URBAN DESIGN COMMISSION APPLICATION

SHEET LIST - ARCHITECTURAL	
SHEET NUMBER	SHEET NAME
PR0.0	COVERSHEET FOR PROPOSED CHANGES
PR1.1	BUILDING 1 & 2 PROPOSED CHANGES - FLOOR PLAN
PR1.2	BUILDING 1 & 2 PROPOSED CHANGES - ELEVATIONS
PR1.3	BUILDING 1 & 2 PROPOSED CHANGES - ELEVATIONS
PR1.4	BUILDING 1 & 2 PROPOSED CHANGES - ELEVATIONS
PR1.5	BUILDING 1 & 2 PROPOSED CHANGES - ELEVATIONS
PR1.6	BUILDING 1 & 2 PROPOSED CHANGES - ELEVATIONS
PR2.1	BUILDING 3 PROPOSED CHANGES - FLOOR PLAN
PR2.2	BUILDING 3 PROPOSED CHANGES - ELEVATIONS
PR2.3	BUILDING 3 PROPOSED CHANGES - ELEVATIONS
PR2.4	BUILDING 3 PROPOSED CHANGES - ELEVATIONS
PR3.1	BUILDING 4 PROPOSED CHANGES - FLOOR PLAN
PR3.2	BUILDING 4 PROPOSED CHANGES - ELEVATIONS
PR3.3	BUILDING 4 PROPOSED CHANGES - ELEVATIONS
PR3.4	BUILDING 4 PROPOSED CHANGES - ELEVATIONS
PR3.5	BUILDING 4 PROPOSED CHANGES - ELEVATIONS

MULTI-FAMILY HOUSING
THE MEADOWLANDS
MADISON, WI
KCG HOUSING DEVELOPMENT

THE MEADOWLANDS - PROPOSED SITE PLAN CHANGES

2 NORTH ELEVATION - BLDG 3 - PROPOSED DESIGN
PR2.3 1/8" = 1'-0"

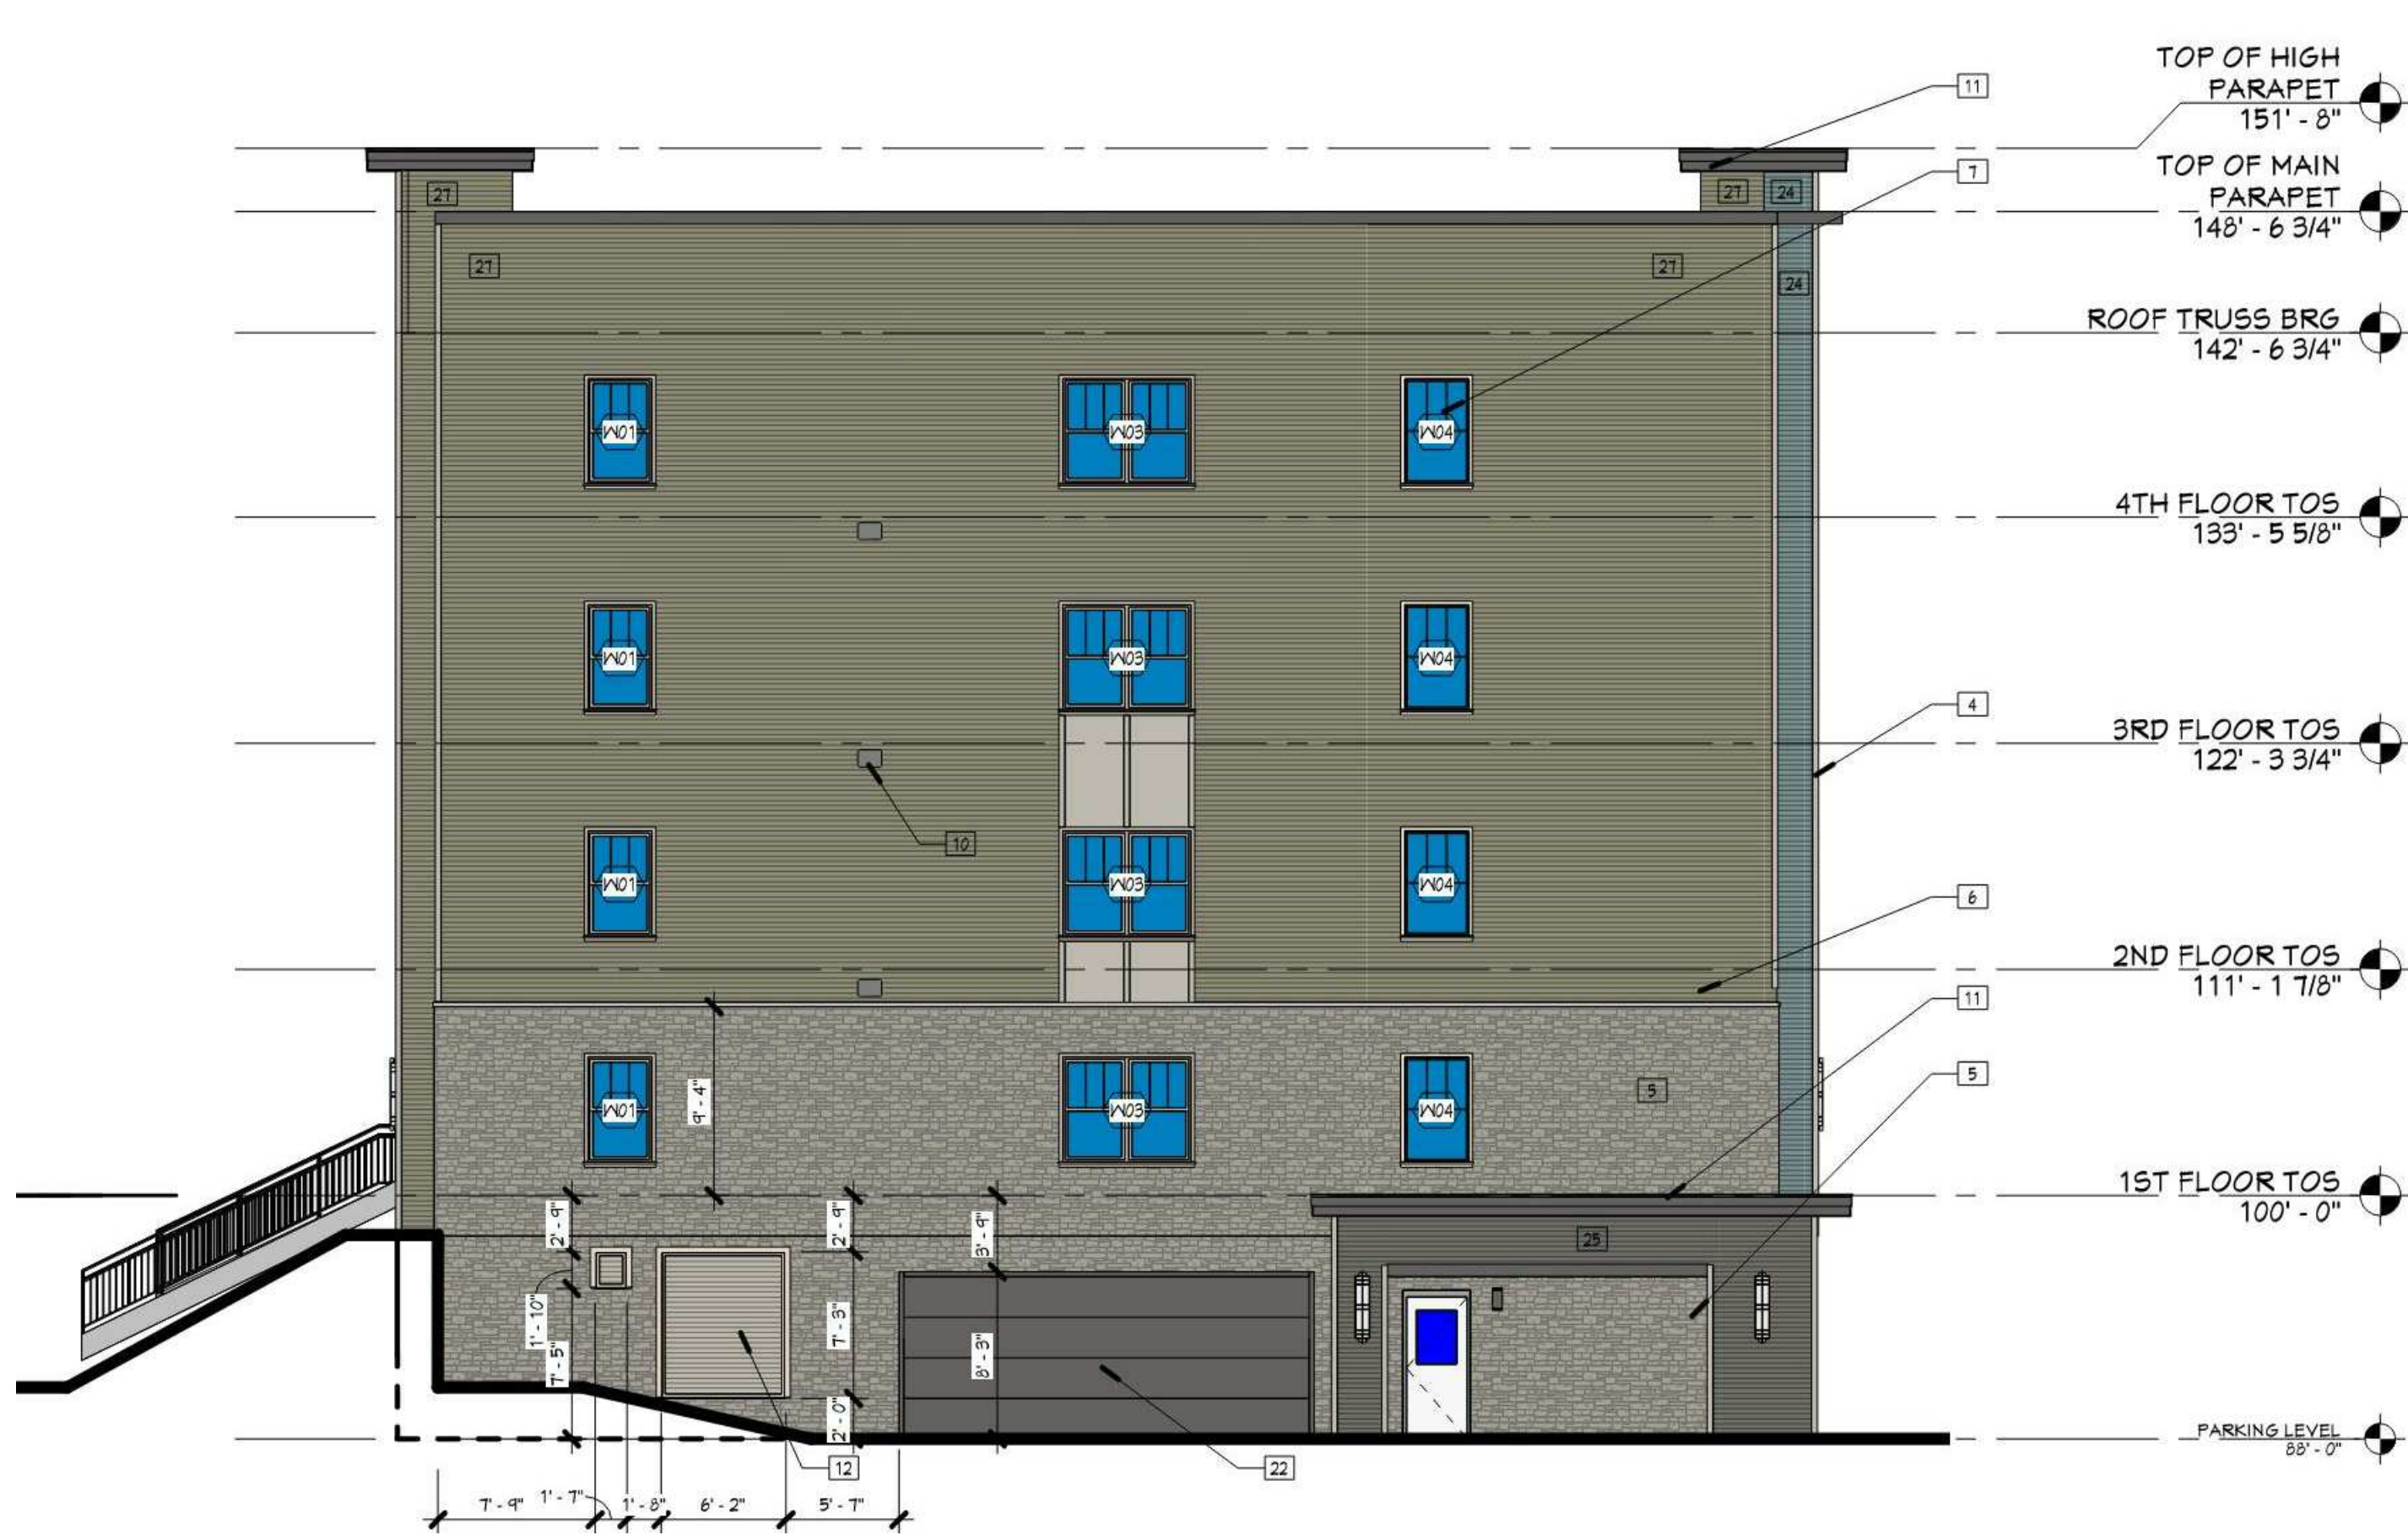
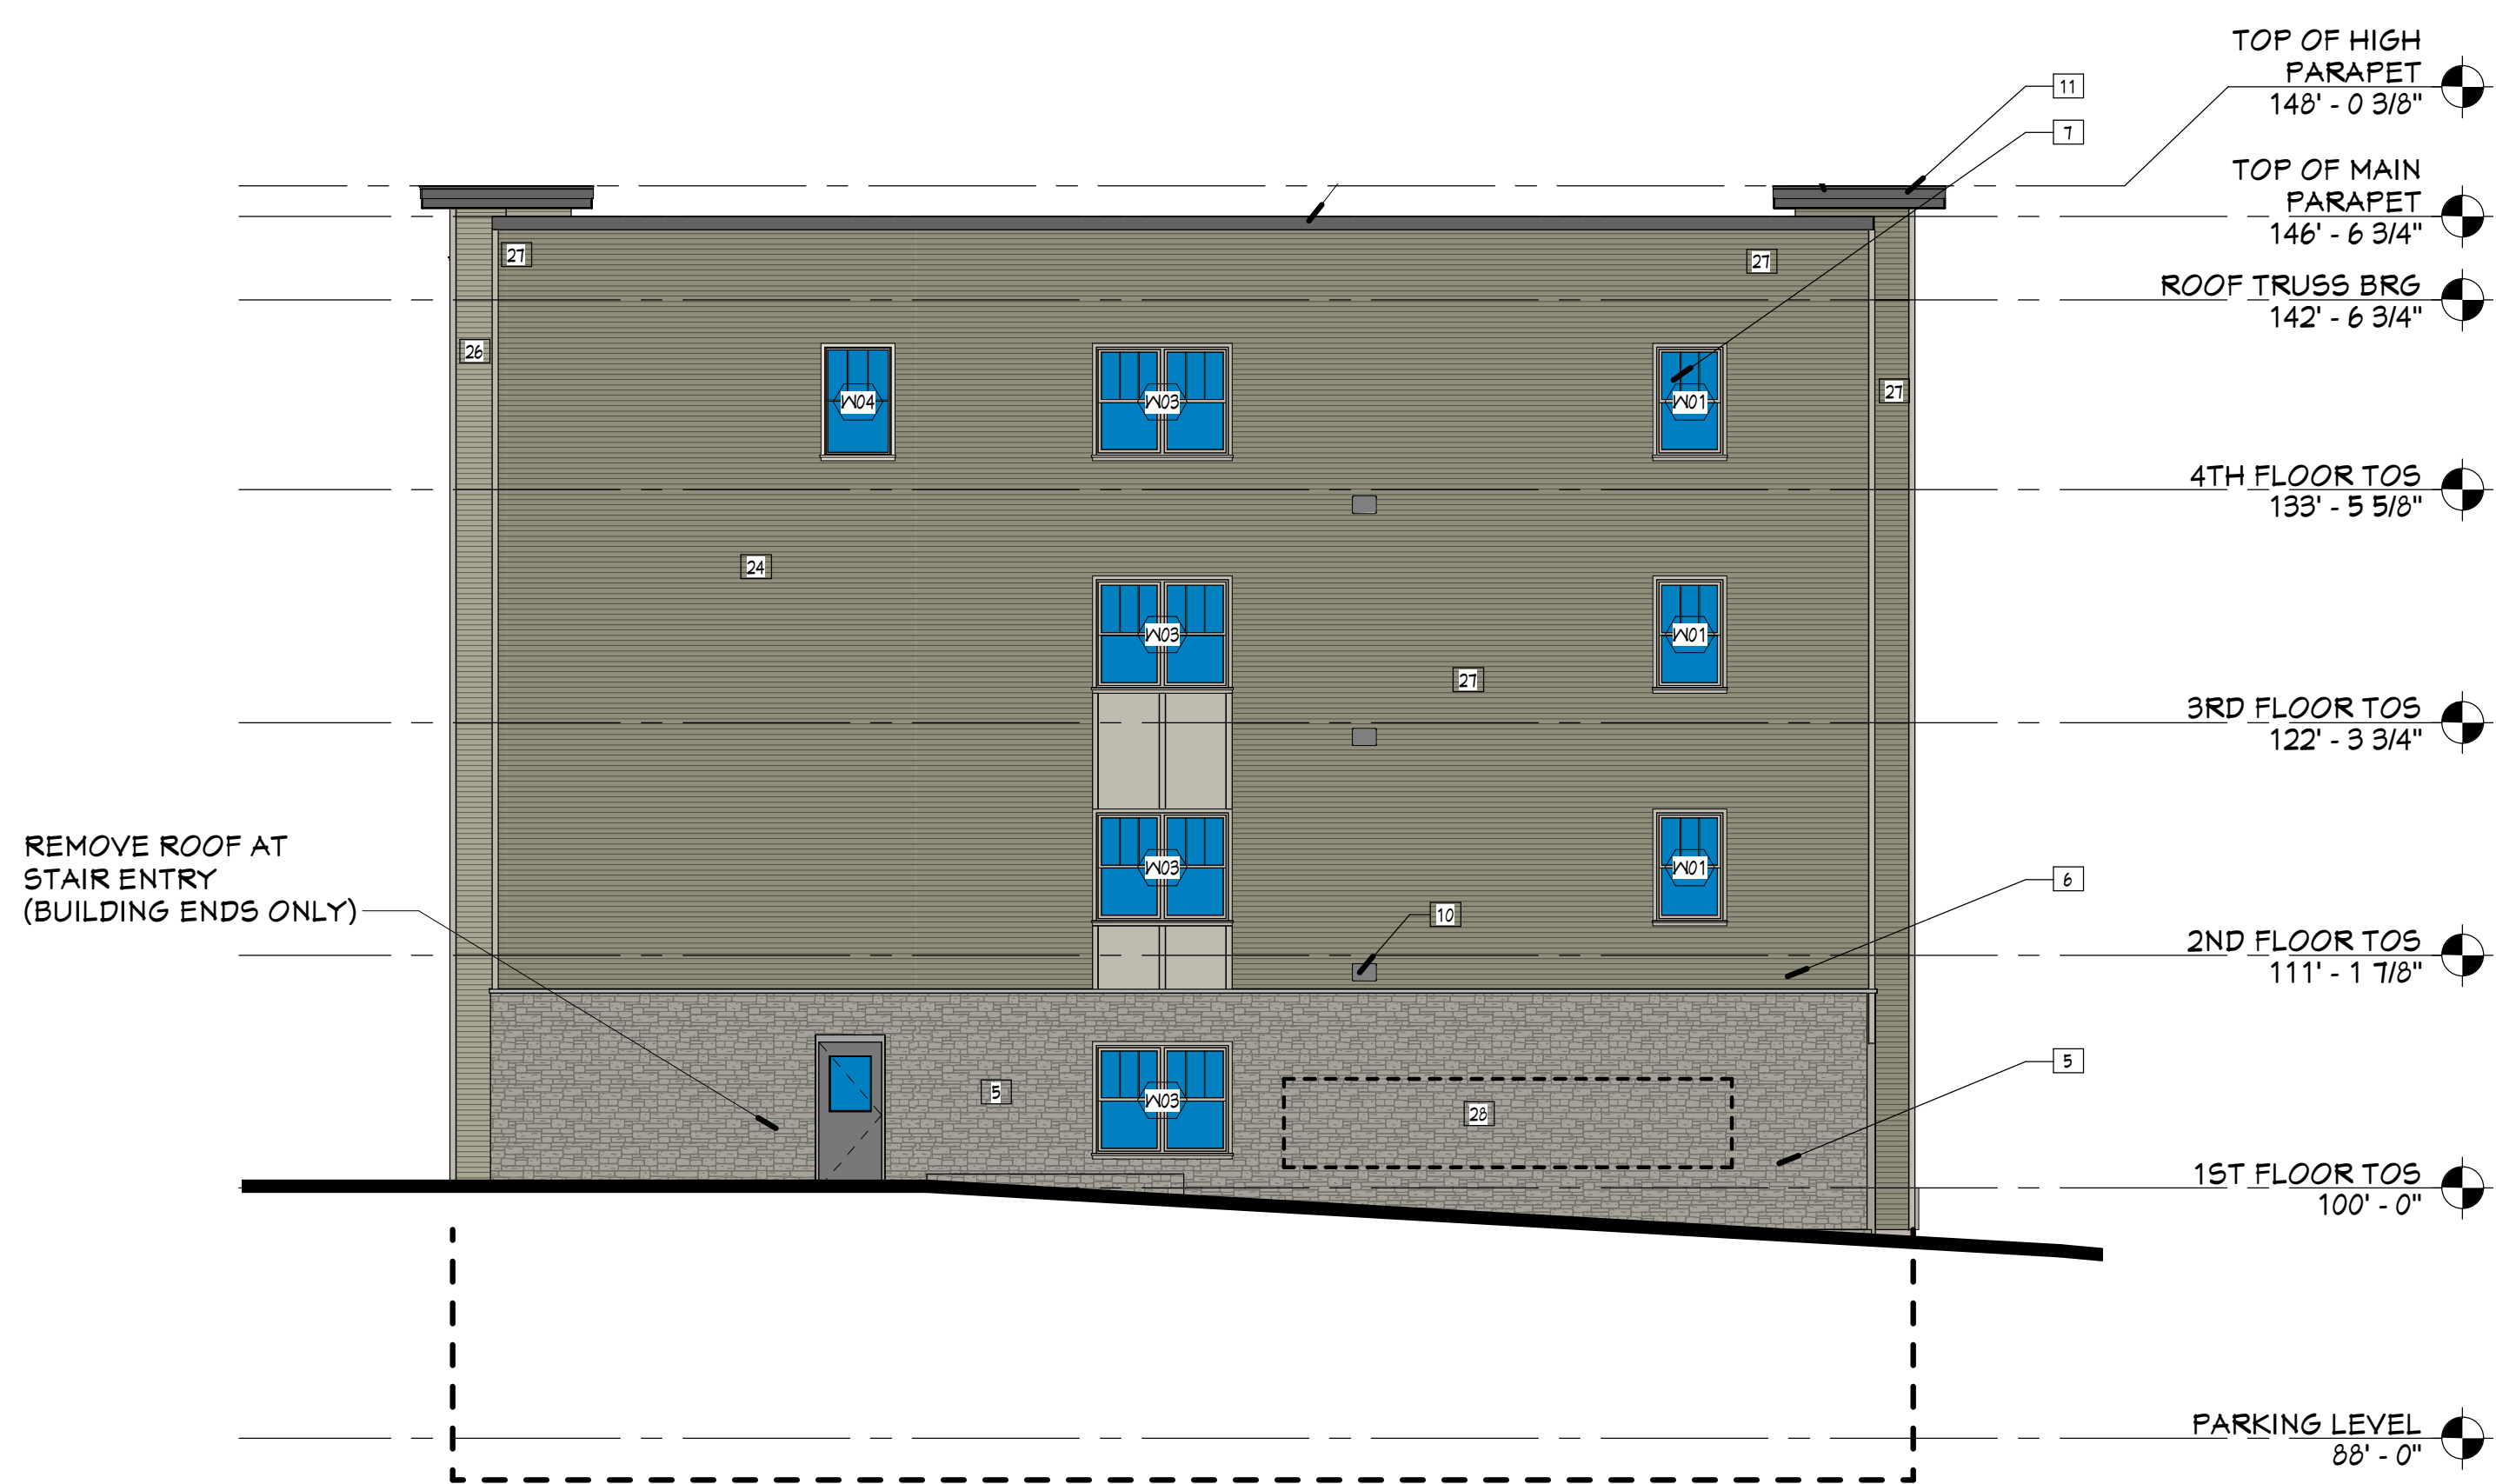
1. REMOVE STEPS TO FIRST FLOOR PRIVATE PATIOS AND ASSOCIATED SIDE WALKS.
2. DECORATIVE SCONCES REMOVED (LIGHTING PLACED IN SOFFIT ABOVE WHERE APPLICABLE)
